Item ID: D206-667-107BL Accept *N900040100* Setup Start *NS1*
 Revision ID:
 Item Name: Fwd Crosstube - Mid Height 206L / L1 / L3 / L4, Blue Stop *NS2*
 Start Date: 8/14/2015 Start Qty: 1.00 *1* Cust Item ID:
 Required Date: 8/14/2015 Req'd Qty: 1.00 *1* Customer:
 Reference:

DRAWING NO. D206-667-147
TITLE CROSSTUBE ASS'Y (206L MID FWD)

DRAWING NO. D206-667-147	TITLE CROSSTUBE ASS'Y (206L MID FWD)	REV. A	DART AEROSPACE LTD ENGINEERING ORDER		D.E.O. NO. D206-667-147-A-1	SHEET NO. SHEET 1 OF 1	SCALE NTS
DRAWN <i>92</i>	CHECKED <i>ASS</i>	MFG. APPR. <i>JS</i>	APPROVED <i>MD</i>		DE APPR. <i>MD</i>		
DATE 11.07.15	DATE 11.07.20	DATE 11.07.21	DATE 11/07/21		DATE 11.07.21

DRAWING NO. D206-667-147	TITLE CROSSTUBE ASS'Y (206L MID FWD)	REV. A	DART AEROSPACE LTD ENGINEERING ORDER	D.E.O. NO. D206-667-147-A-2	SHEET NO. SHEET 1 OF 1	SCALE NTS
DRAWN AJS	CHECKED	MFG. APPR.	APPROVED	DE APPR.		
DATE 12.08.02	DATE 12.08.02	DATE 12.08.02	DATE 12.08.02	DATE 12.08.02	DATE 12.08.02

DETAIL P
BONDING STRAP INSTALLATION 2 PL

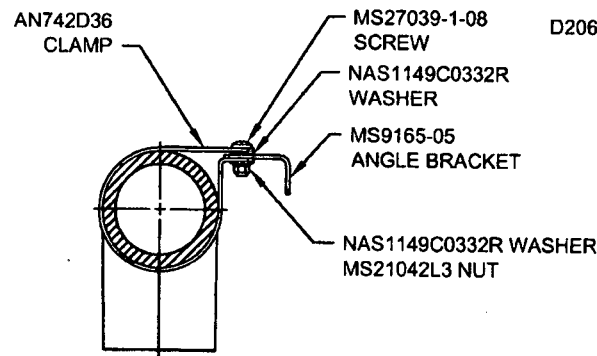
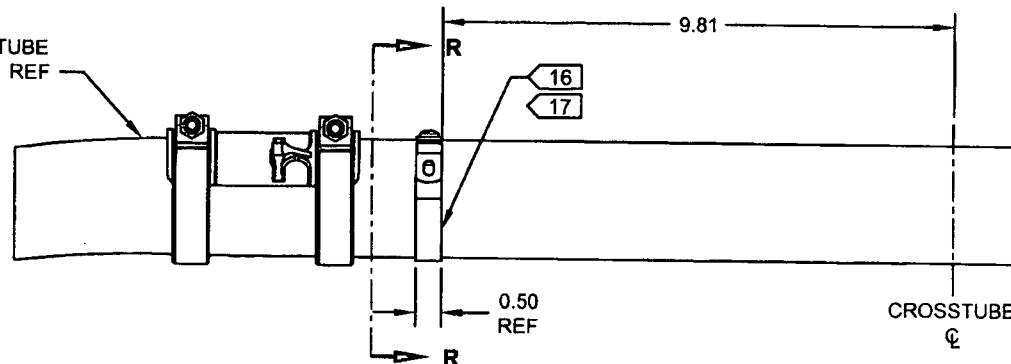
ADD ELECTRICAL GROUNDING STRAP

ITEM	QTY -147	PART NUMBER	DESCRIPTION
1	X	D206-667-147	CROSSTUBE ASSEMBLY (206L MID FWD)
10	2	AN742D36	CLAMP
11	2	MS9165-05	ANGLE BRACKET
12	2	MS21042L3	NUT (OR MS21042-3)
13	2	MS27039-1-08	SCREW
14	4	NAS1149C0332R	WASHER (OR AN960C10L)

- 16) MASK AREA UNDER CLAMP PRIOR TO PAINTING
 17) SEAL EDGES WHERE AN742D36 CLAMP MEETS WITH THE CROSSTUBE USING SIKAFLEX-241/-291 OR MIL-S-8802 CLASS B2 OR PROSEAL 890 SEALANT
 18) PERFORM RESISTANCE CHECK TO ENSURE MAX RESISTANCE IS 10 MILLIOHMS
